December 19, 1990  
C311-90-2146  
(TAC 59151)

Subject: Three Mile Island Nuclear Plant, Unit 1 (TMI-1)  
Operating License DPR-50  
Docket No. 50-289  
ATWS Design Implementation Simplification of Protective  
Action

# DSS LOGIC FIGURE 1

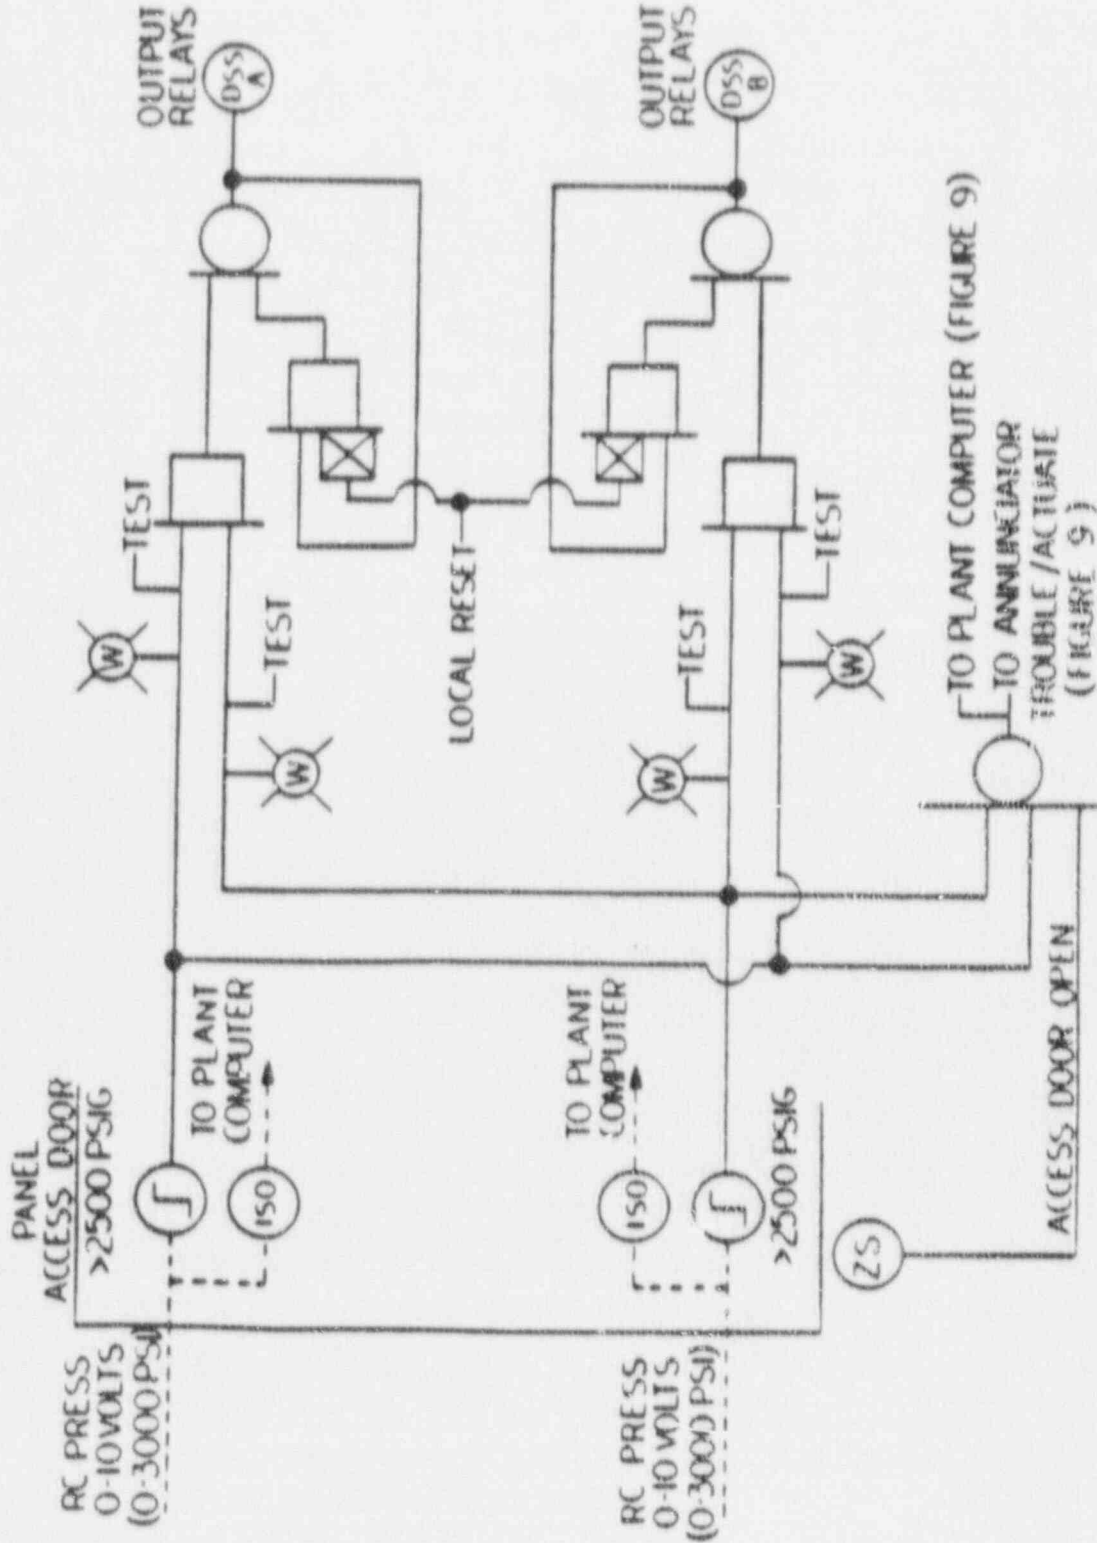
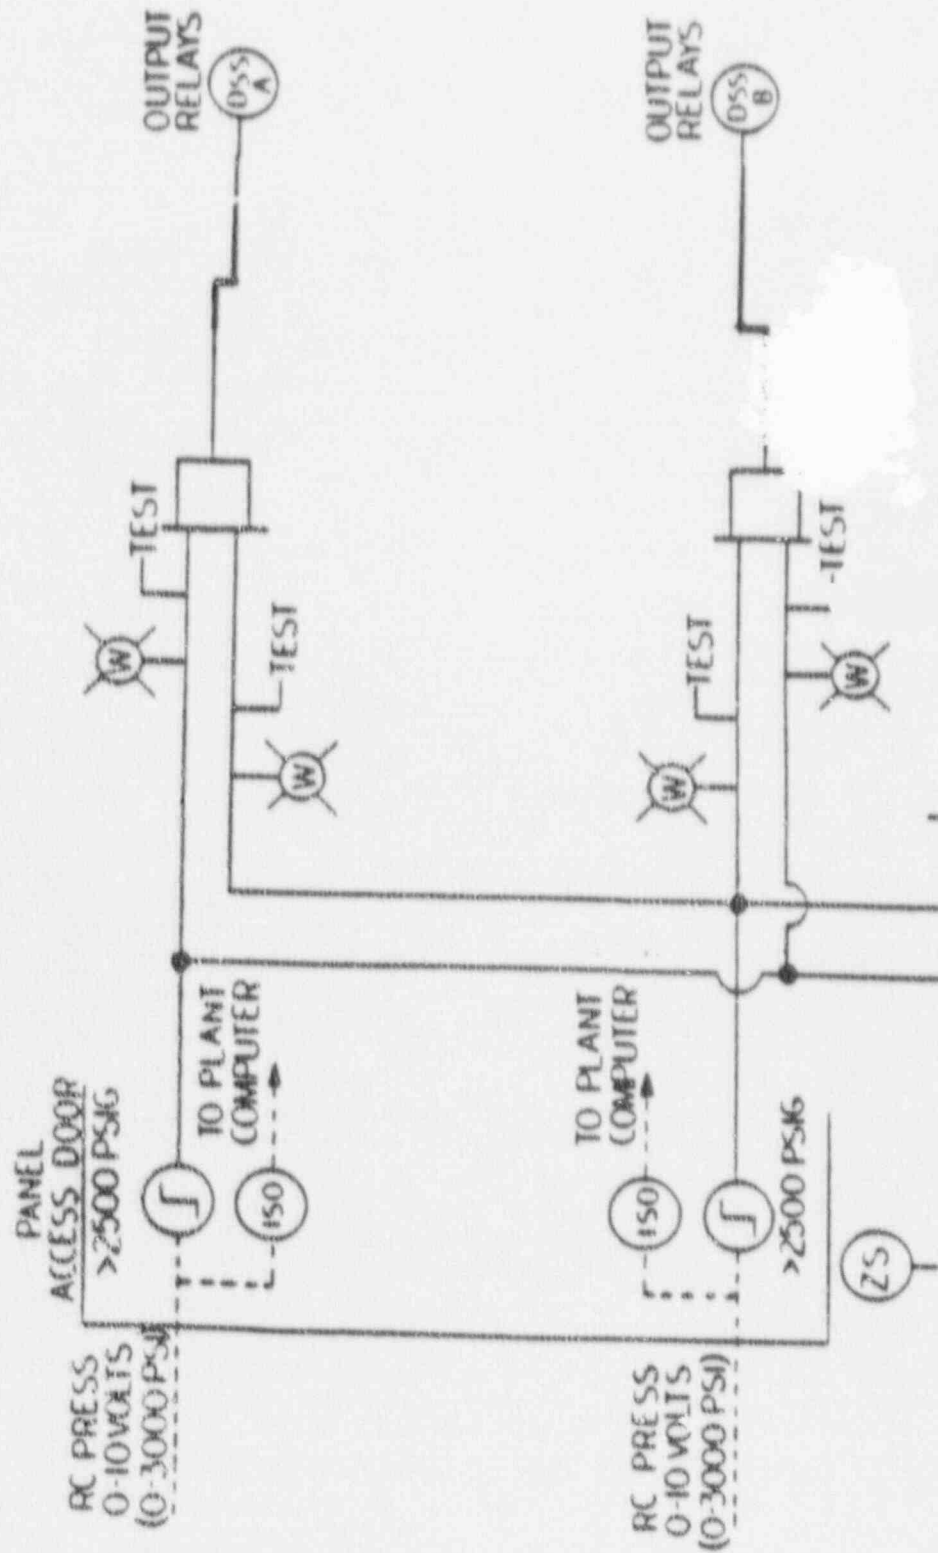
GPUN has now simplified the DSS logic circuit as depicted on Figure 1A also enclosed with this letter. Lock-up/Seal-in of the DSS trip function is now achieved by the action of circuit breakers 1G-2A and 1L-2A, which lock-in/seal-in inherently, by design. Reset is done locally by the operator at the breakers.

This simplified design achieves a reduction in the number of procedural steps required by an operator to reset a protective actuation. In the original design of Figure 1 the three step procedure consisted of: (1) Reset the actuation; (2) reclose the breaker to energize the Control Rod Drive System (CRDS); and, (3) withdraw control rods using the CRDS. The revised design is more typical of GPUN procedures to reset a protective action. The two step procedure is: (1) reclose the breaker; and, (2) withdraw control rods using the CRDS. The additional step built in to the original design is unnecessary and results in added circuit complexity.
